File/Permit #: OSWP-2024-46707

EXISTING SYSTEM APPROVAL

PIN/Lot Identifier: 4635-86-4051 ✓
Property Location/Address: 353 Camino Real Rd, Mooresville, NC 28117 ✓

Proposed Property Improvement: Addition to the home, remodel the interior, addition to the deck. Bedroom count will not increase.

EXISTING SYSTEM APPROVAL
SITE SKETCH

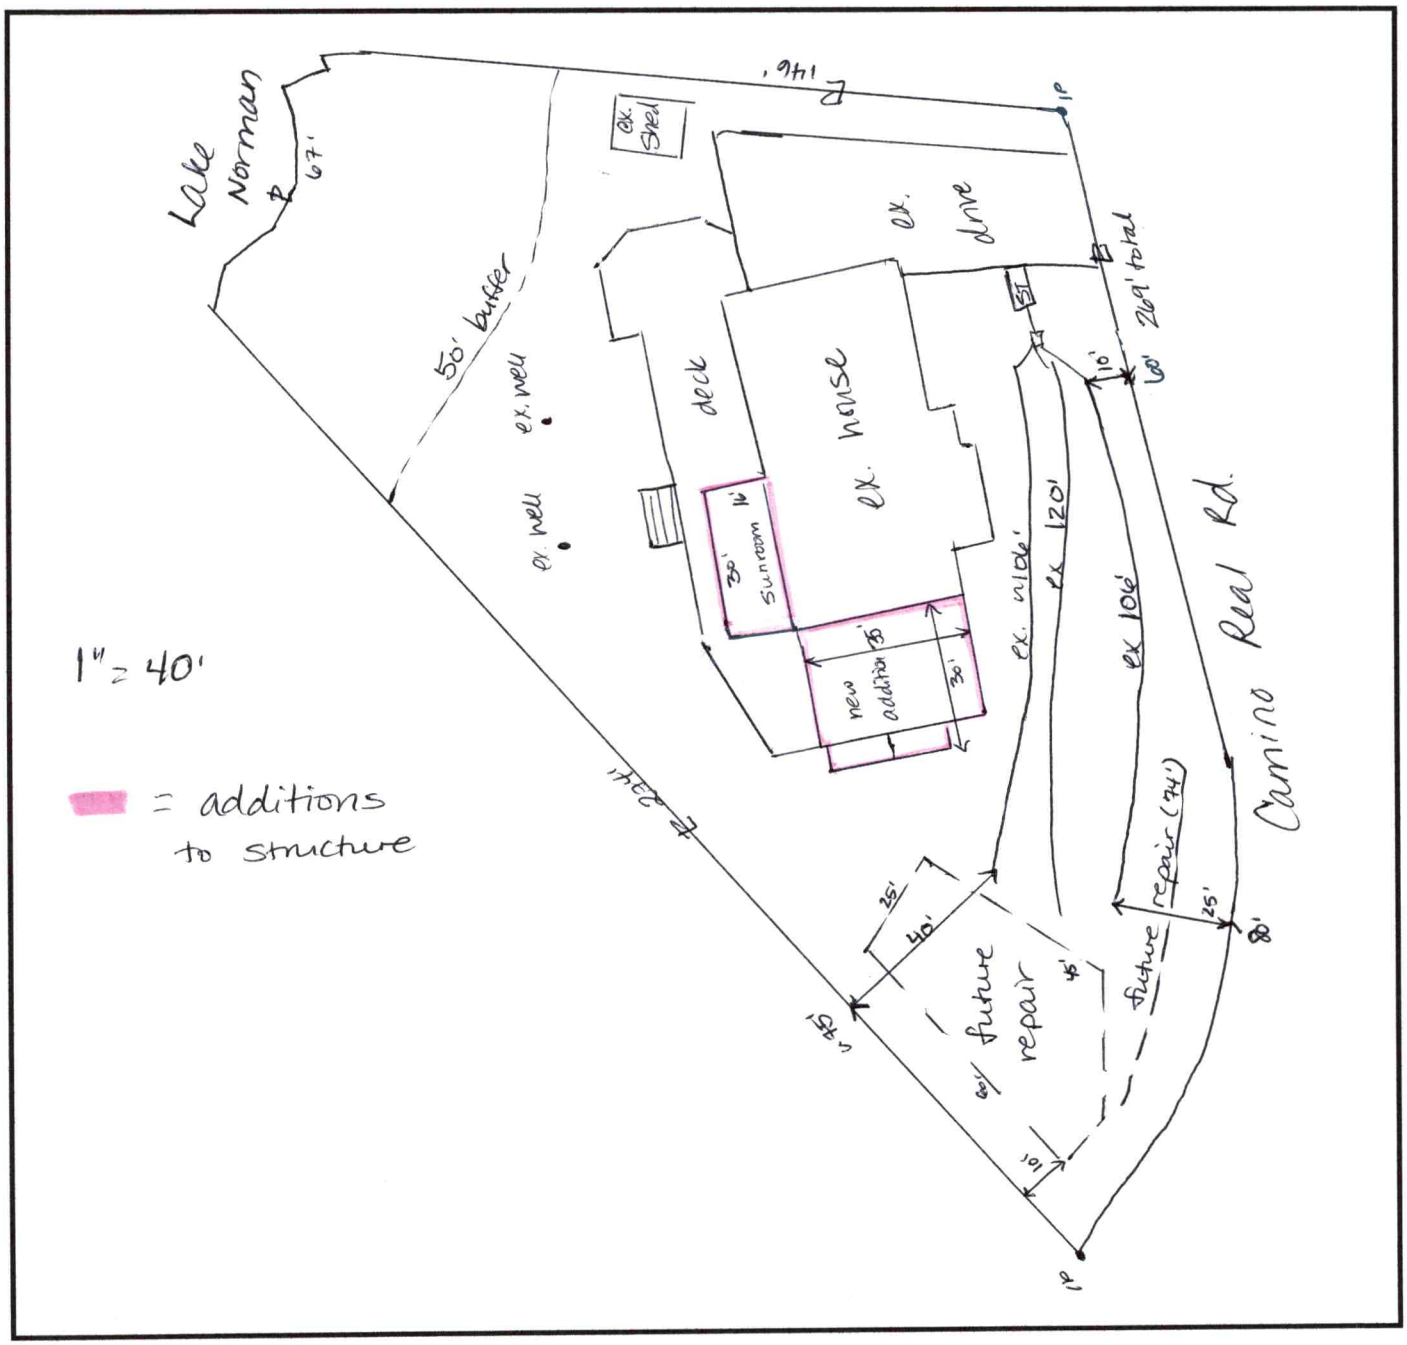
Approval Conditions: Keep structure 10' from all parts of existing system and keep all traffic off of the septic area.
May be 5' from system without foundation drains

Sheet 1 of 1
PROPERTY ID #: 4635-80-4051
COUNTY: Iredell

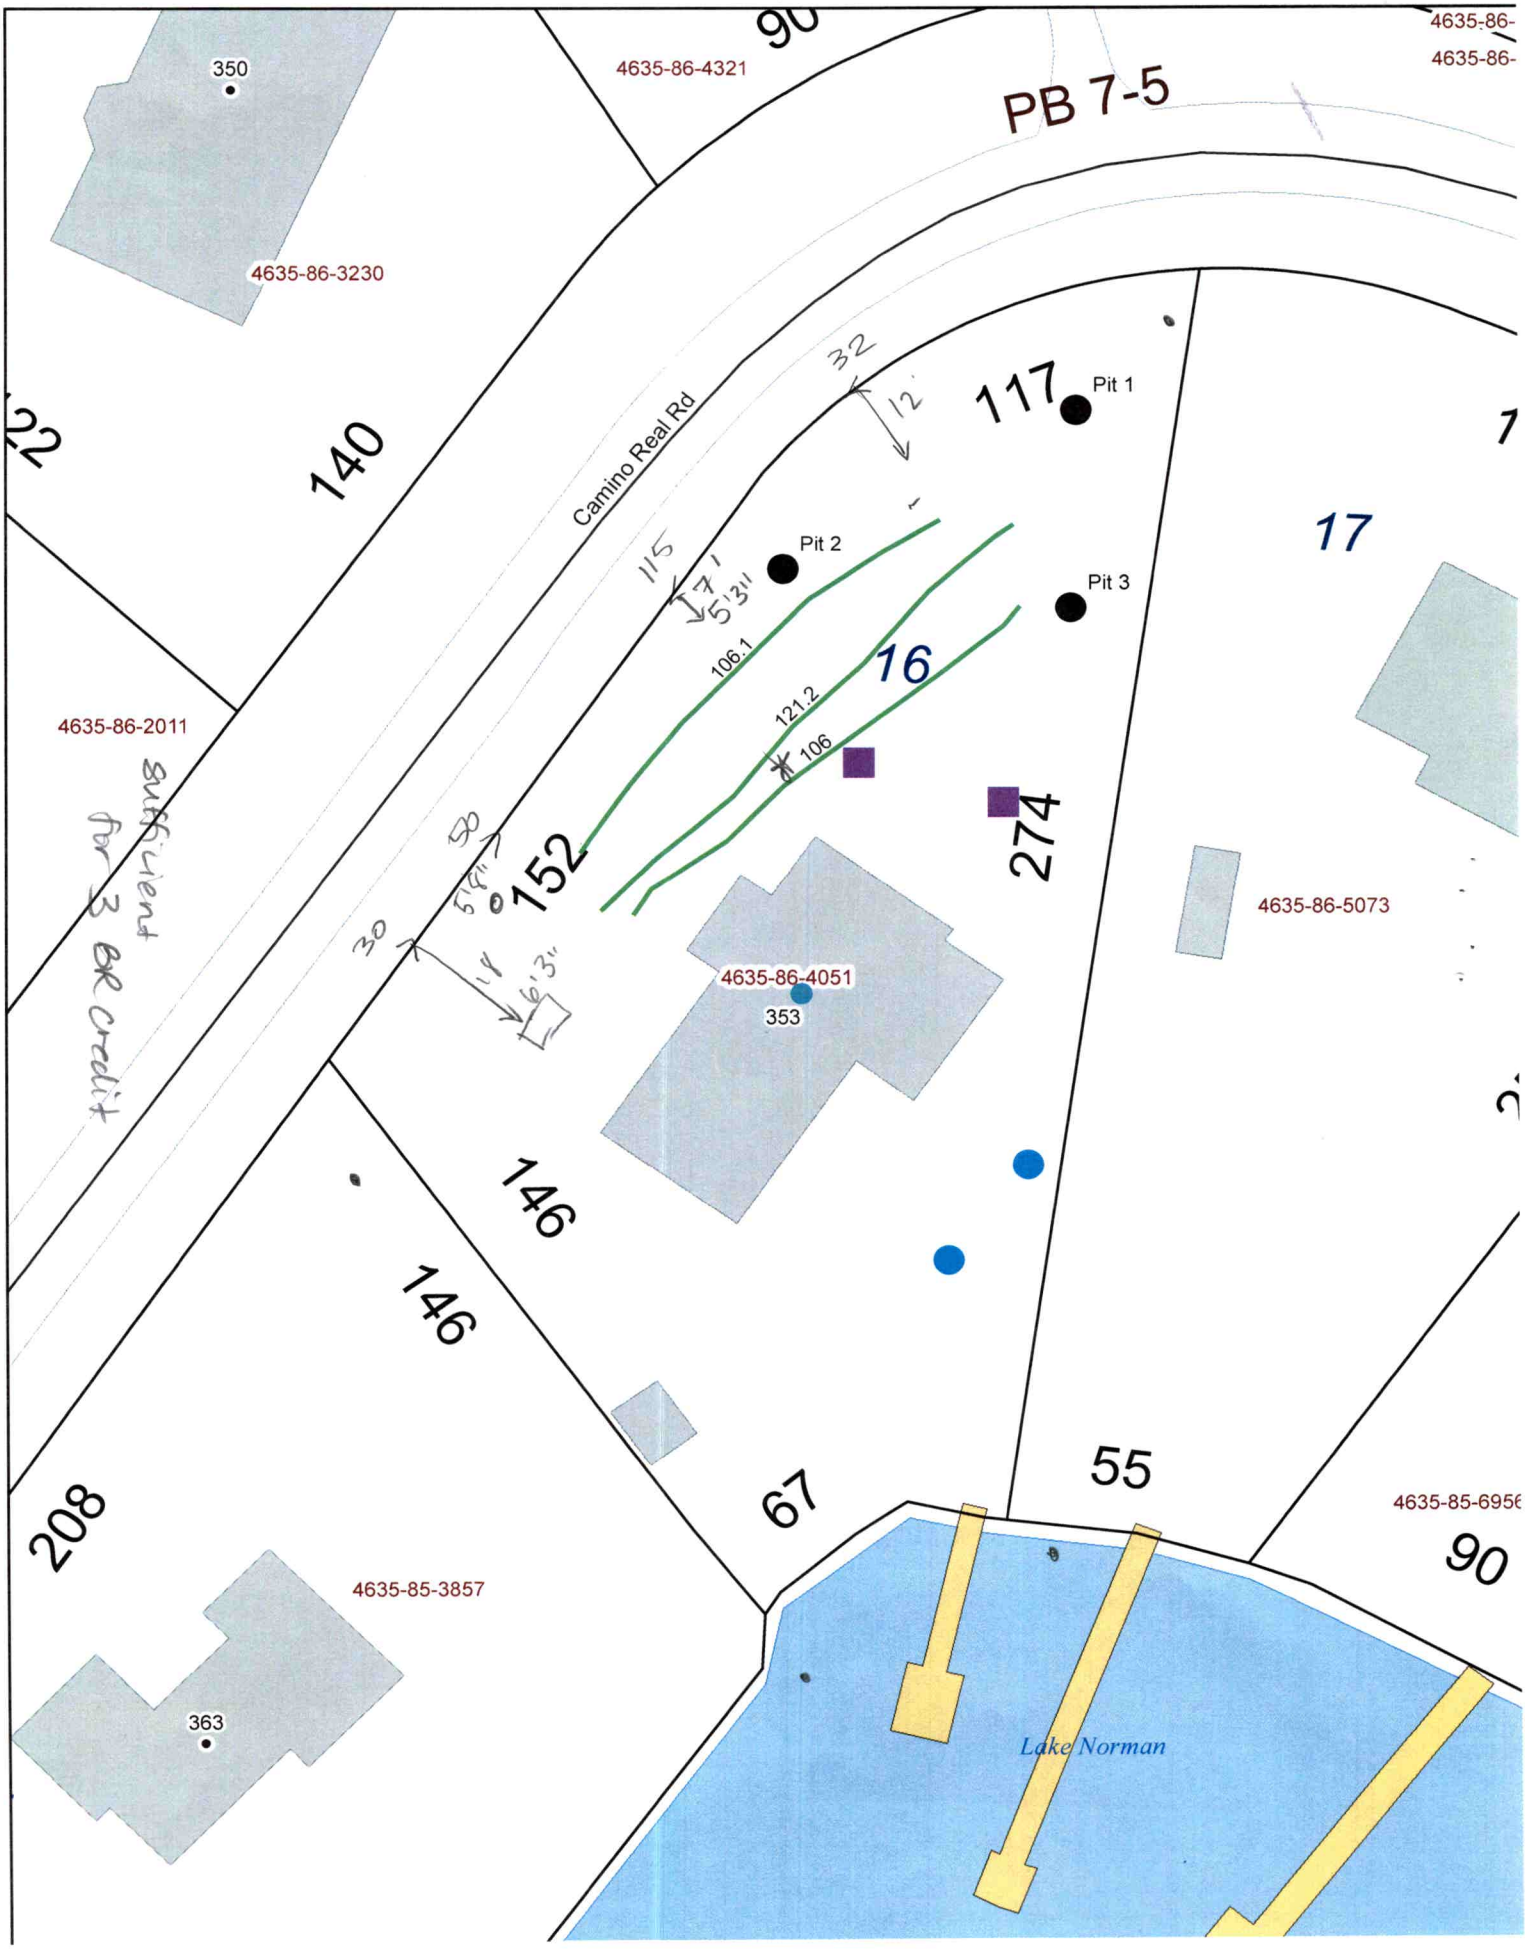
COMMENTS: No permit on file for existing however I felt 332' sufficient to give 3BR credit

PB 7-5
Camino Real Rd
350
4635-86-4321
4635-86-3230
4635-86-2011
4635-86-5073
4635-86-4051
353
4635-85-3857
363
4635-85-6956
140
152
146
146
208
67
55
90
274
117
Pit 1
Pit 2
Pit 3
16
17
32
12'
115
7'1"
5'3"
106.1
121.2
106
30
50
5'4"
14'
6'3"
sufficient for 3 BR credit
Lake Norman
